Contract No. DC/2020/02

Construction of San Shek Wan Sewage Treatment Works,  
Associated Submarine Outfall and Pui O Sewerage Works

Submission No.: KLCWJV/1027/1763-2022  
Submission Title: **Silt Curtain Deployment Plan (SCDP) (Rev.11)**  
Submission Date: 28 April 2022

## Construction and installation of pre-cast emergency outfall

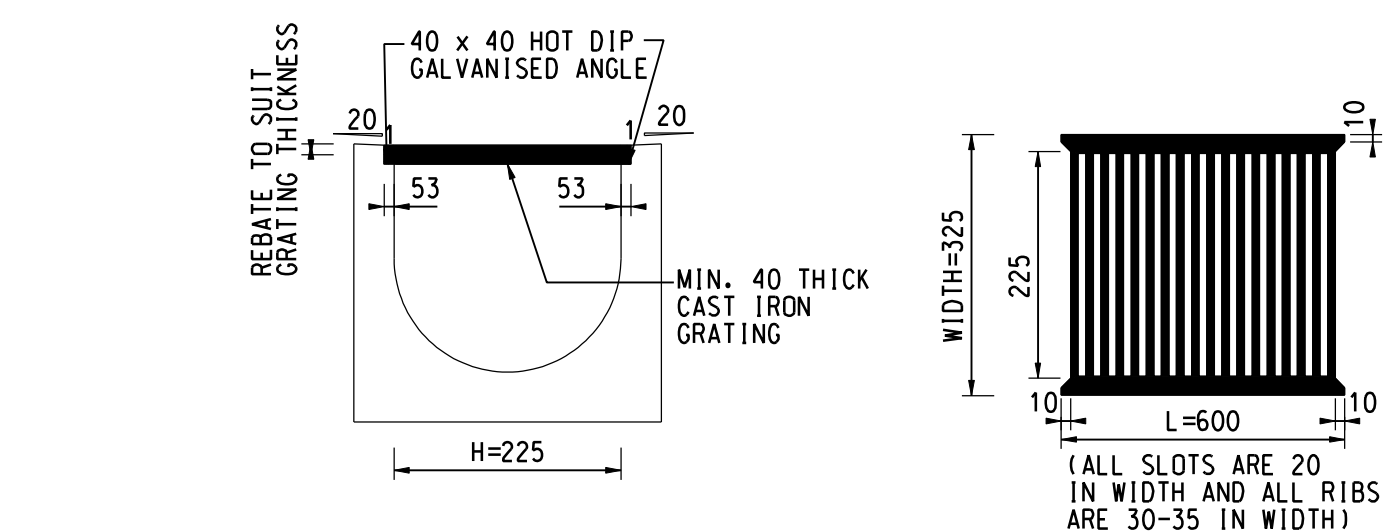
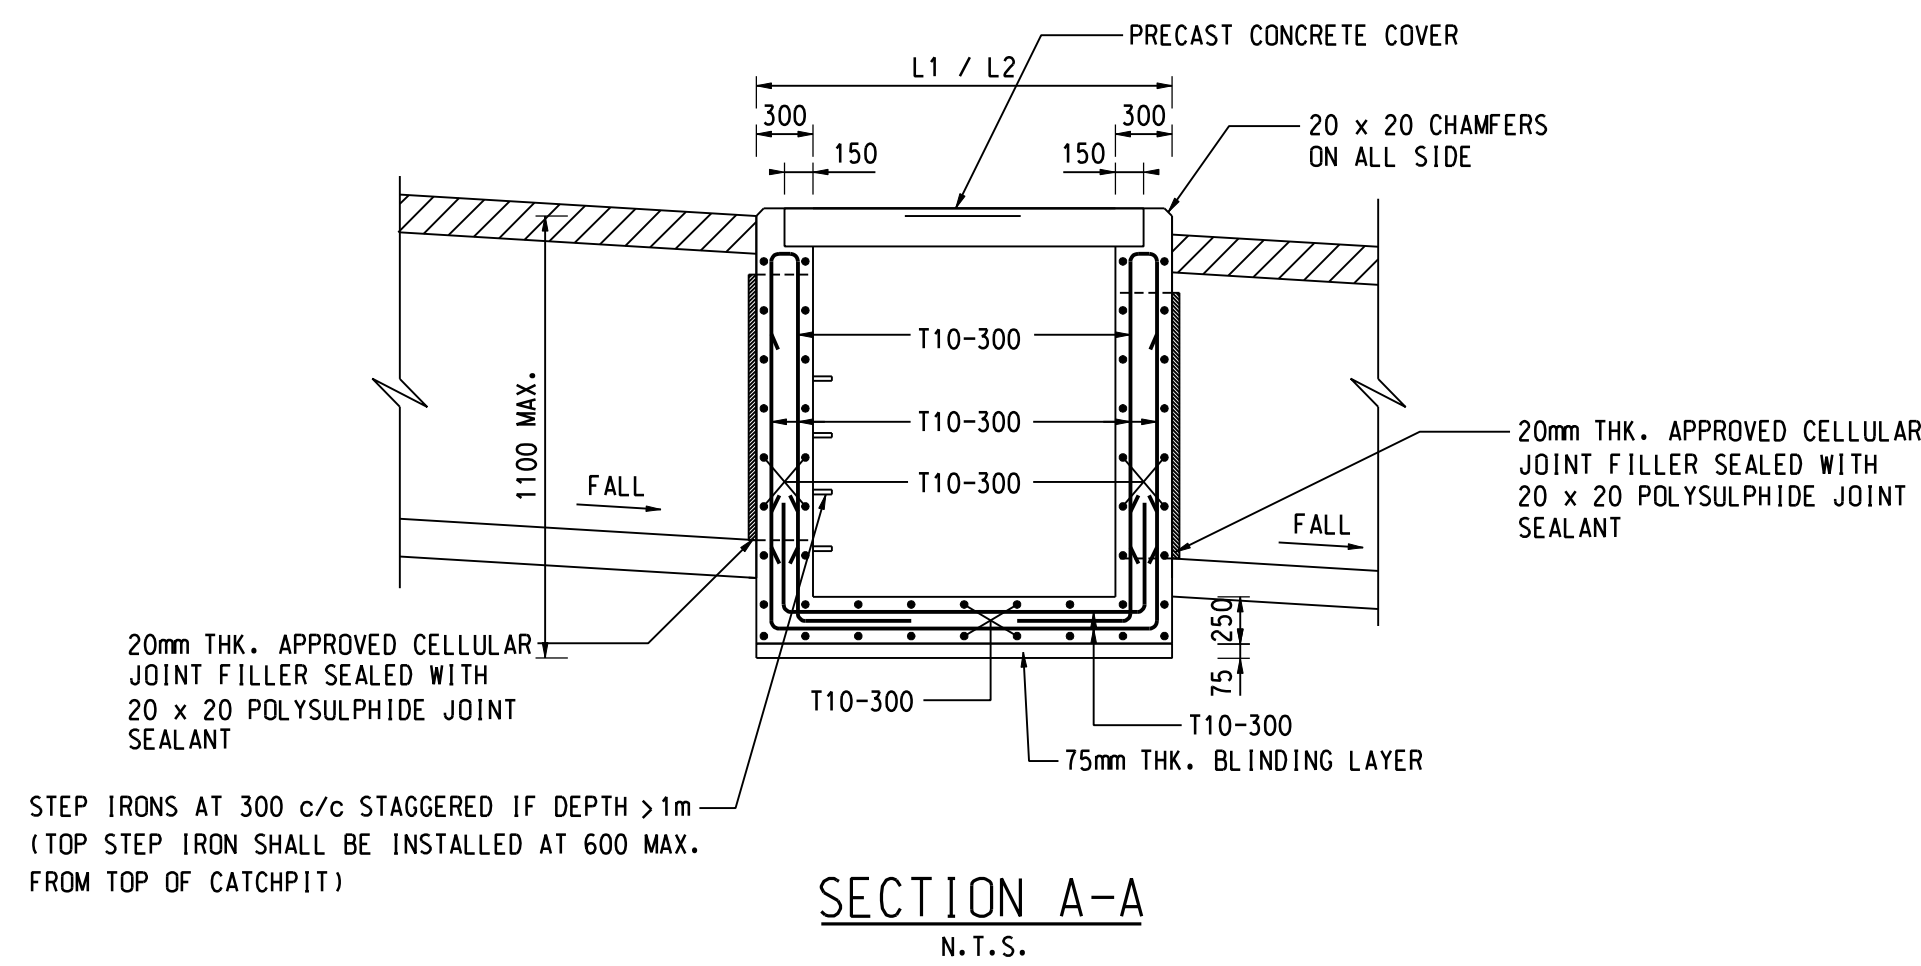
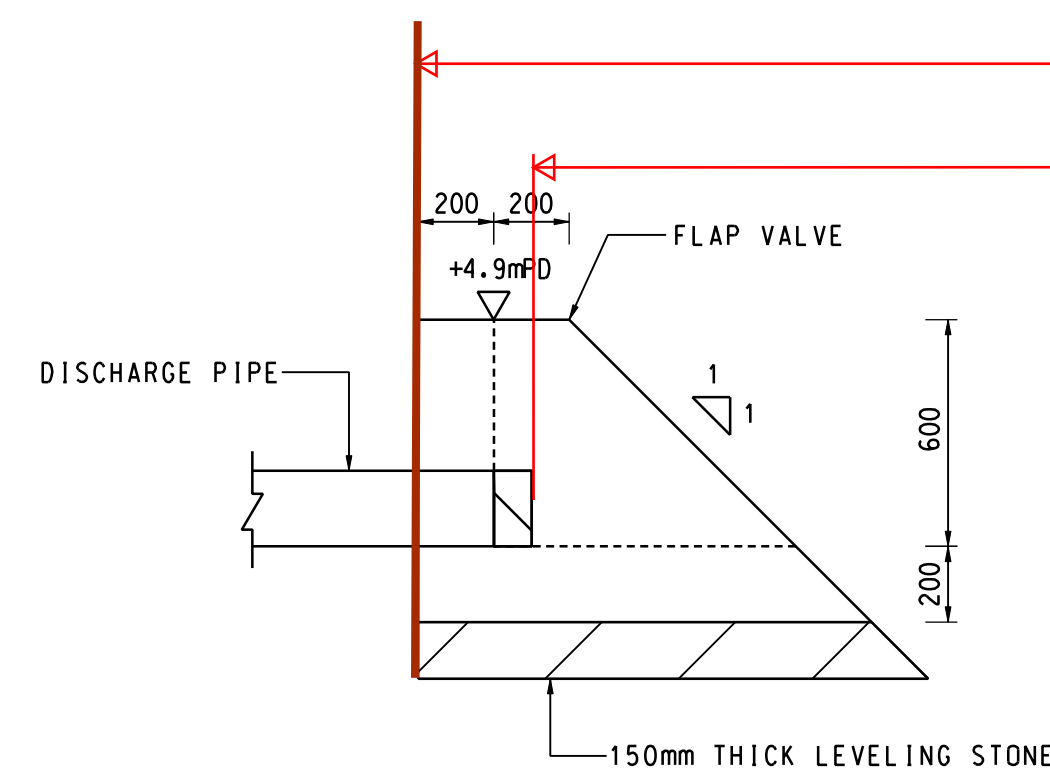
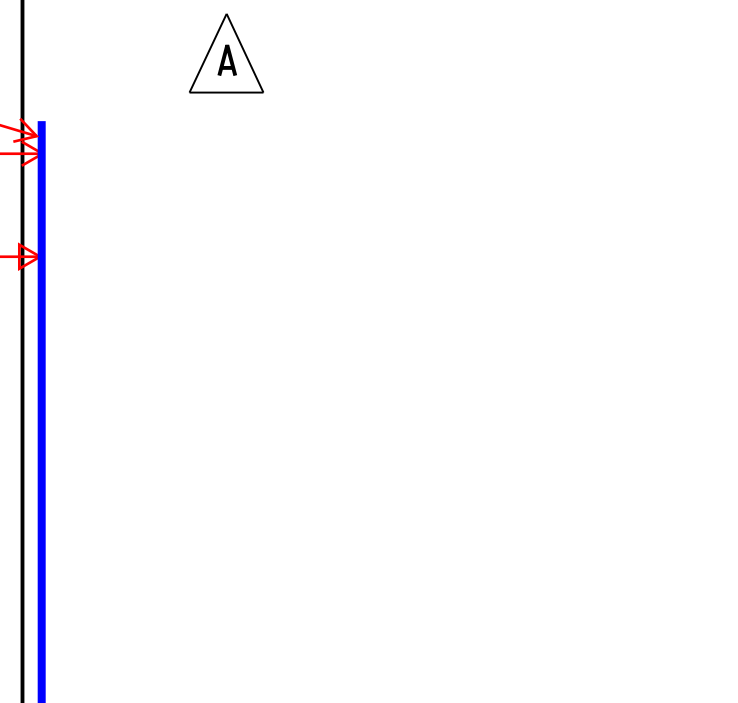
| Item No. | Ref.                                                         | Comments                                                                                                                                                                                                                                                                 | Contractor's Response                                                                                                                                                                                                   |
|----------|--------------------------------------------------------------|--------------------------------------------------------------------------------------------------------------------------------------------------------------------------------------------------------------------------------------------------------------------------|-------------------------------------------------------------------------------------------------------------------------------------------------------------------------------------------------------------------------|
| 2.a.     | Comment from EPD (Ref.: ( ) in Ax (13) to EP 2/N9/F/50 Pt.7) | S.2 –<br>The Contractor had clarified that no dredging work would be carried out for the construction and installation of precast emergency outfall (Stage 4). Please supplement the purpose of deployment of silt curtain for the works at Stage 4 in relevant section. | For stage 4, levelling stone will be laid on the seabed and the precast outfall structure will be constructed on top of the levelling stone. Silt curtain should be deployed to prevent stirring-up of seabed material. |
